Westinghouse  
Electric Corporation

NSD-NRC-97-4998  
DCP/NRC0752  
Docket No.: STN-52-003

SUBJECT: INFORMAL CORRESPONDENCE

## Attachment 1 to Westinghouse Letter DCP/NRC0752

Figure 3B-10

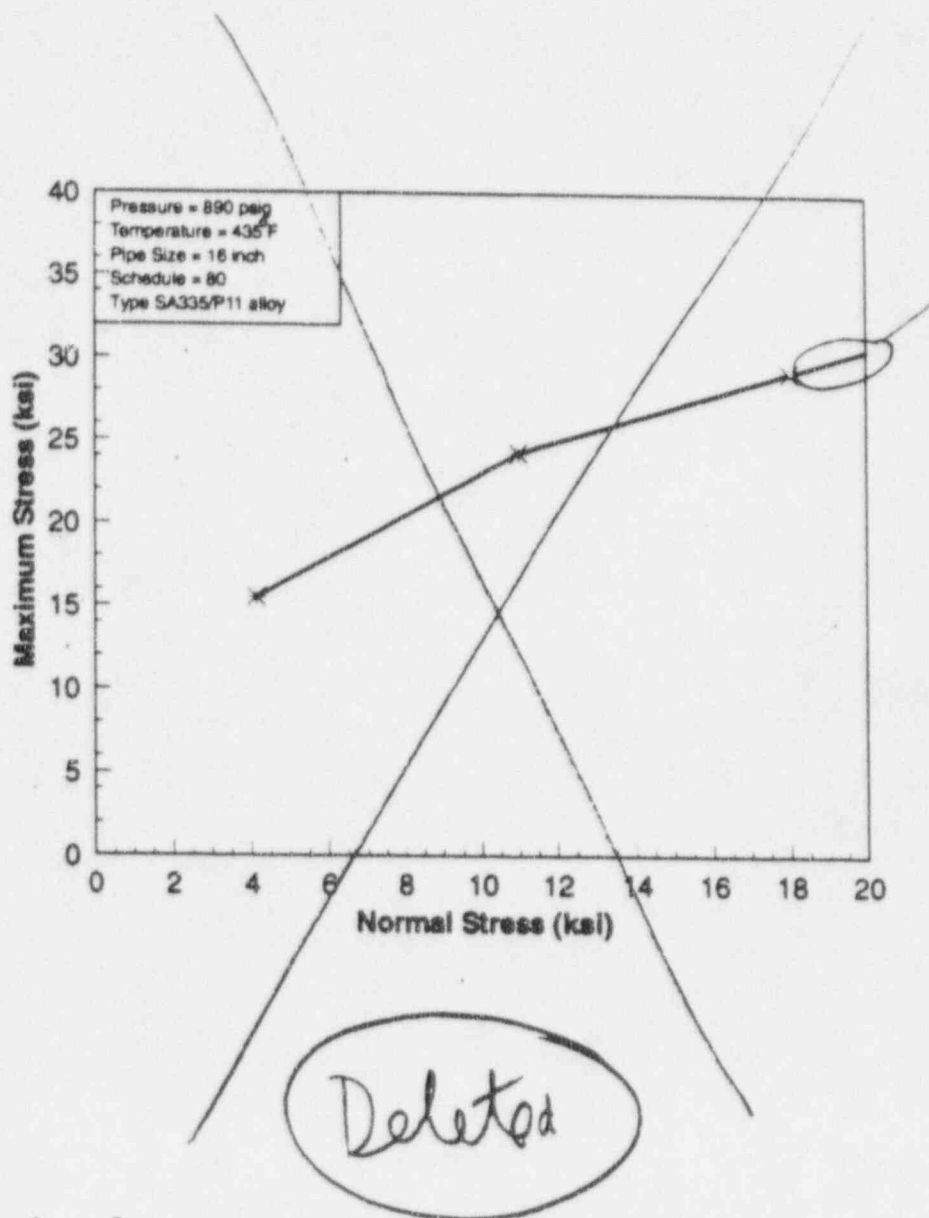
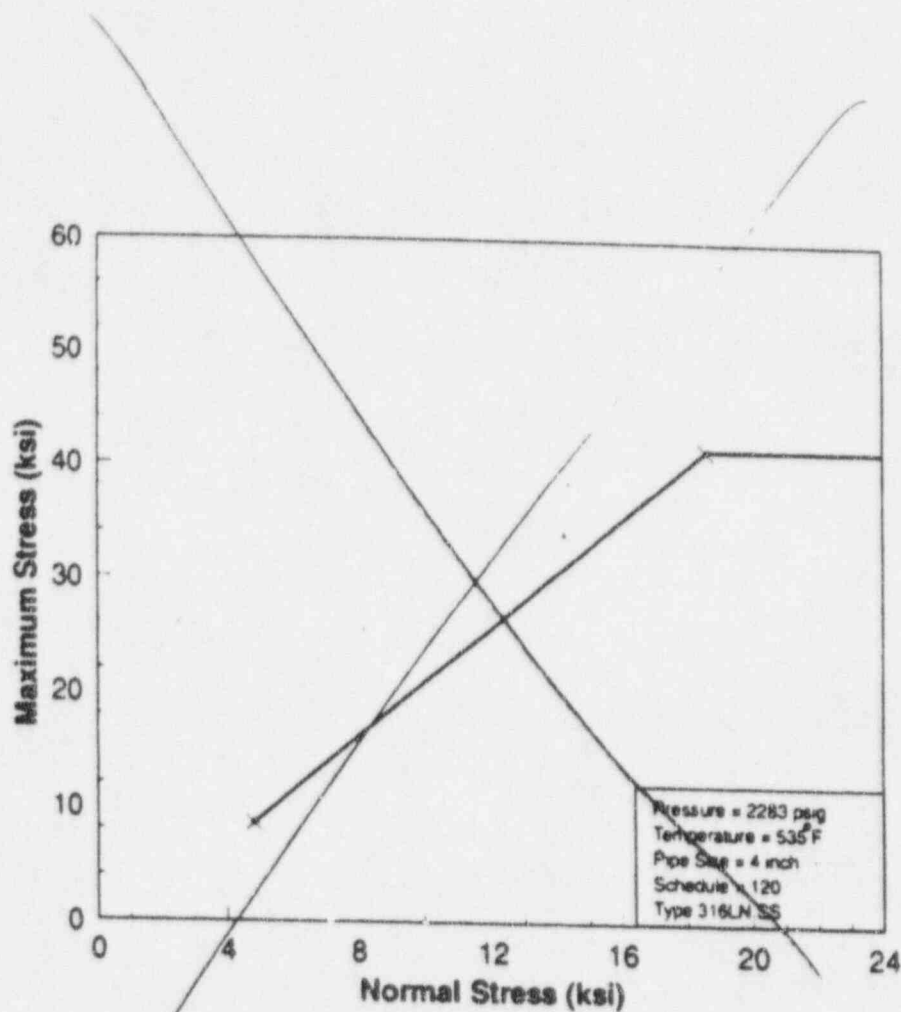
Table 3B-2 shows a summary of piping systems and corresponding bounding analysis figures. Figures 3B-2 (o 3B-9 and 3B-10) to 3B-40 (35) show the bounding analysis curves. The curves satisfy the margins as indicated in subsection 3B.3.

Figure 3B-36

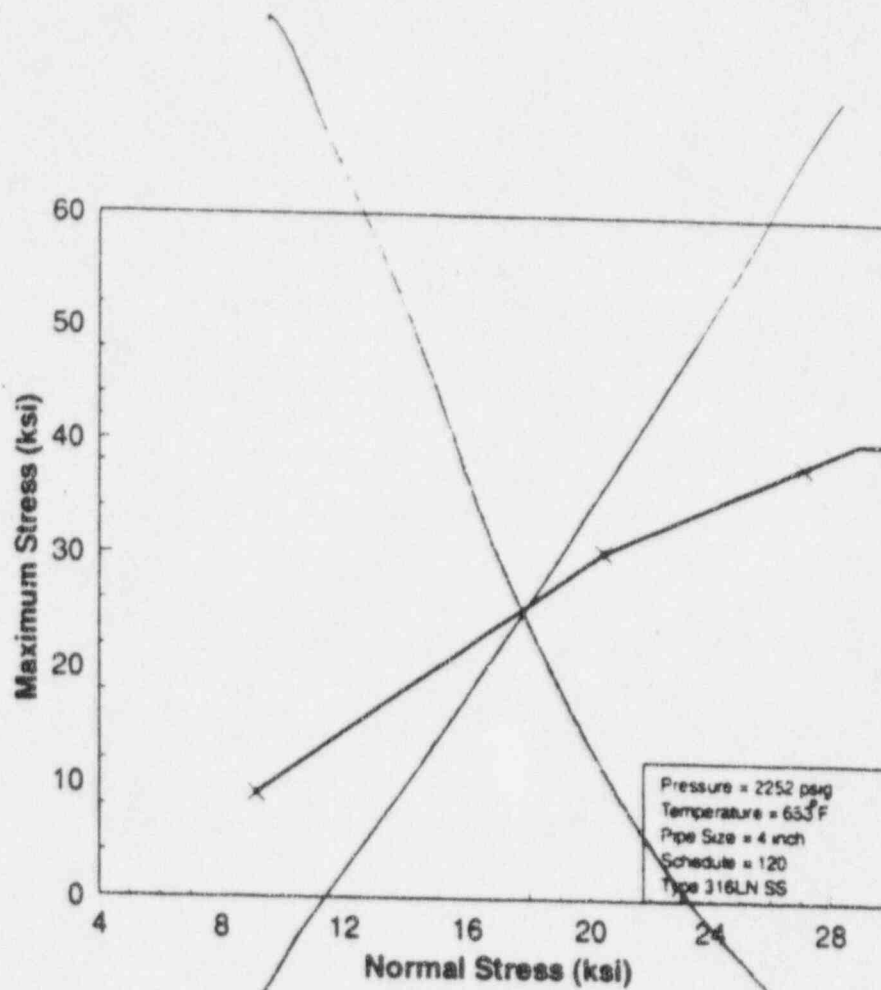
Deleted

Figure 3B-37

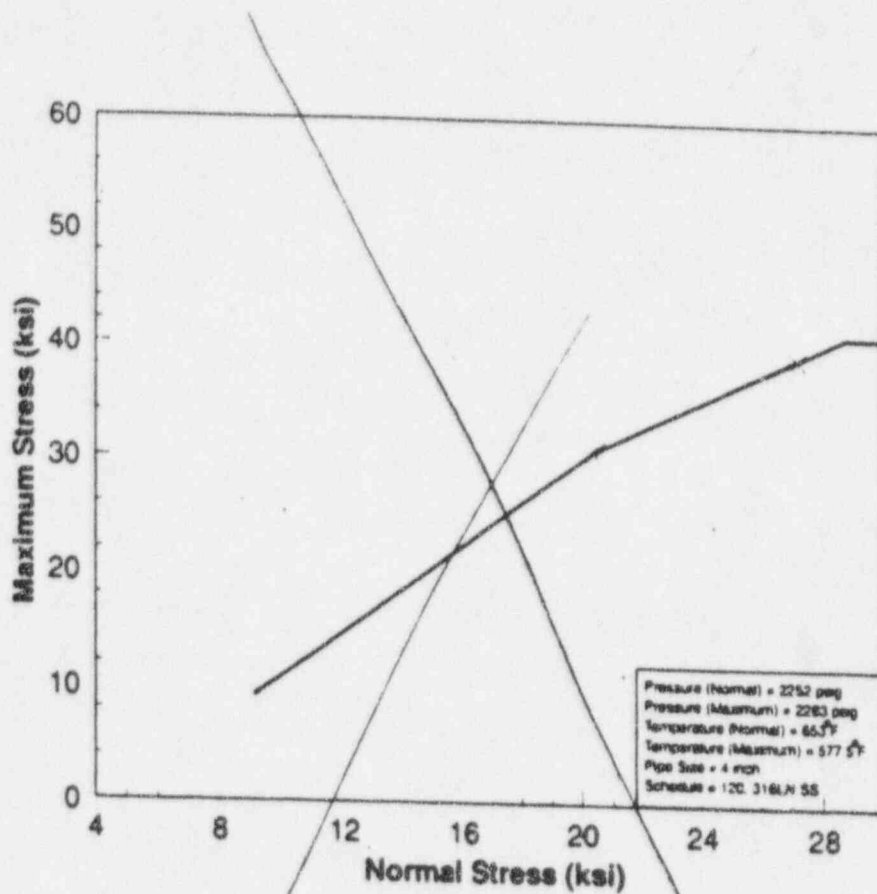
Deleted

Figure 3B-38

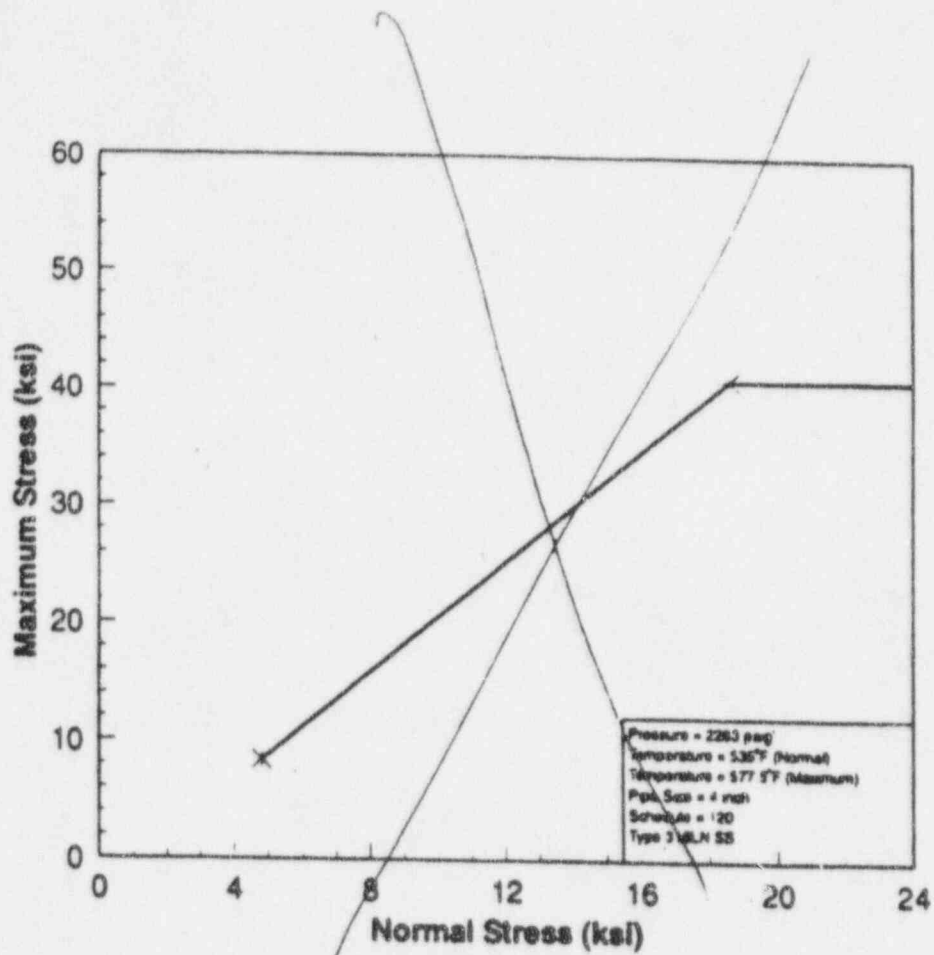
Deleted

Figure 3B-39

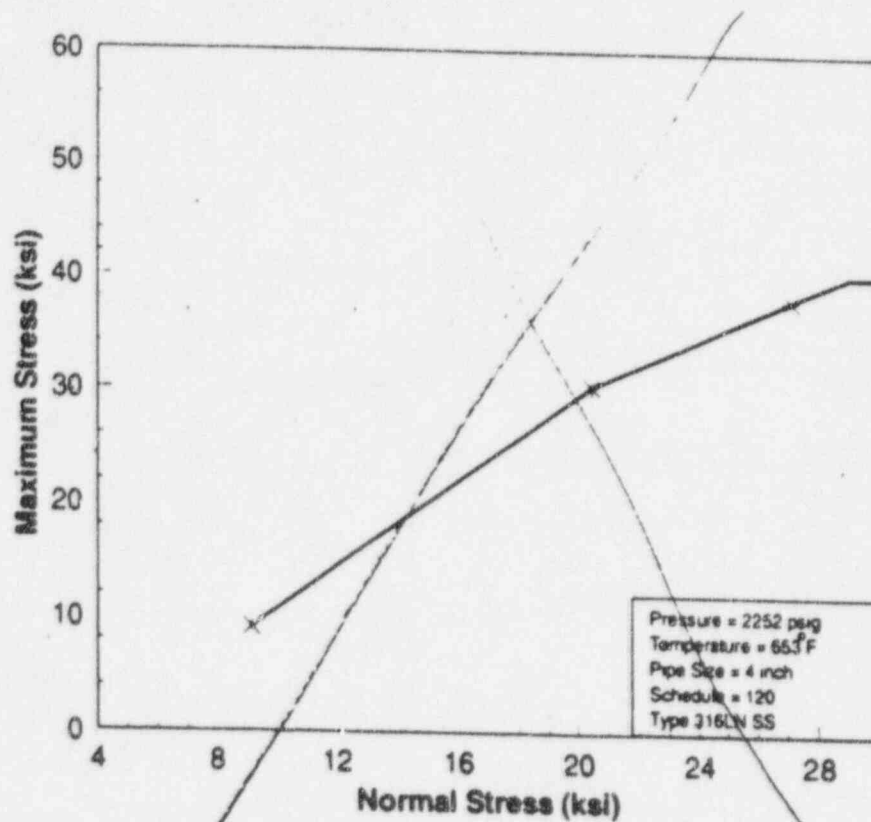
*Deleted*
